TP2 J3u value

Contribution to support comment # 86 .3ck D2.2 Review Cycle

TP2 J3u value : 802.3ck D2.2 Comments

Figure 162B-3—Mated test fixtures differential-mode to differential-mode insertion loss

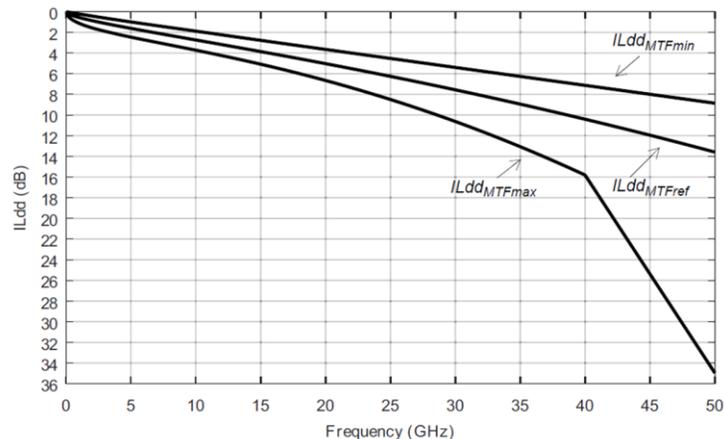
From the standpoint of being able to confirm electrical interoperability of a CR Transmitter Port by inserting an HCB and evaluating the signal properties, TP2 is kind of important. The Jitter values at TP2 are currently based on an unlikely set of minimum values (0dB package loss and 4.1dB MTF loss). Under these conditions 10.975dB net loss, the current J3u value of 110mUI is nominally attainable.

Bert output Total Path Loss (dB)	Bert FIR	J3U (mUI)	JRMS (mUI)
8	0/ 0.03/ -0.15/ 0.7/-0.08	75	10
15	-0.01/0.05/ -0.18/ 0.55/ -0.21	120	16

Figure 163-3—Transmitter test fixture and test points

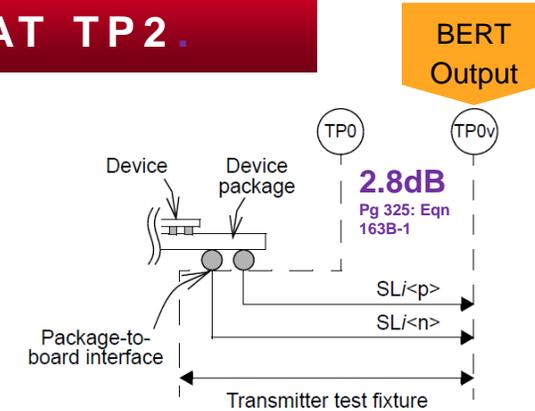
Worst case loss at TP0-TP2 is 6.875dB (host) + 8.5dB (fixture max) = 15.37dB
 Package loss ~4dB. Net loss from Tx to TP2 is ~19.37dB

.3ck (162.9.3) should permit edge compensation (equalization) at TP2 to allow better focus on measuring uncorrelated jitter, rather than the effects of slew rate limits and noise.

Experimental Setup

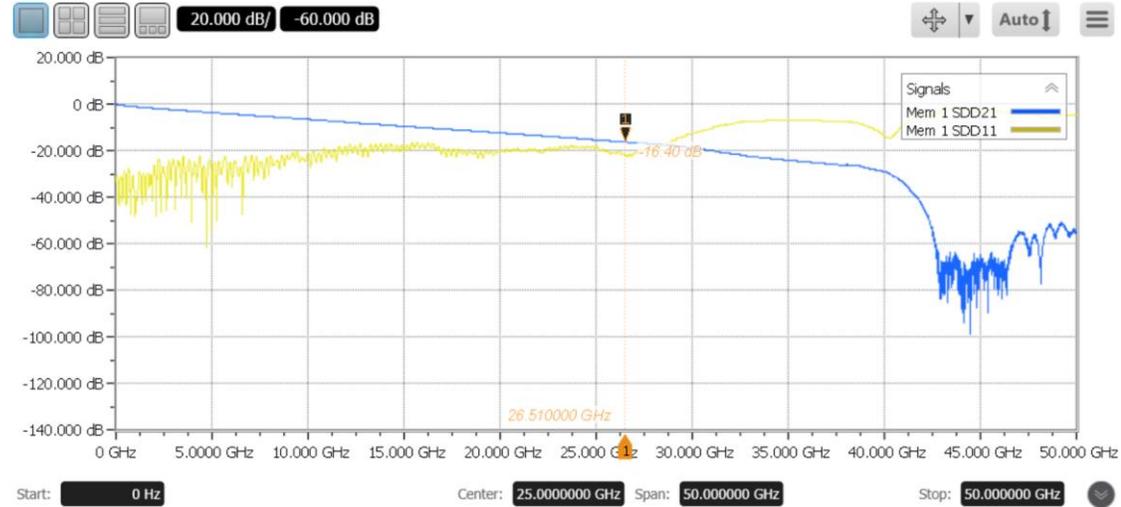
Measurement	To L0	To L1	To L2	To L3
⊖ J3u (All)	120 mUI			
From L3	70 mUI	90 mUI	120 mUI	---
From L2	80 mUI	140 mUI	---	130 mUI
From L1	110 mUI	---	120 mUI	85 mUI
From L0	---	140 mUI	95 mUI	68 mUI
⊕ Jrms (All)	16 mUI			
⊕ EOJ (All)	22.0 mUI
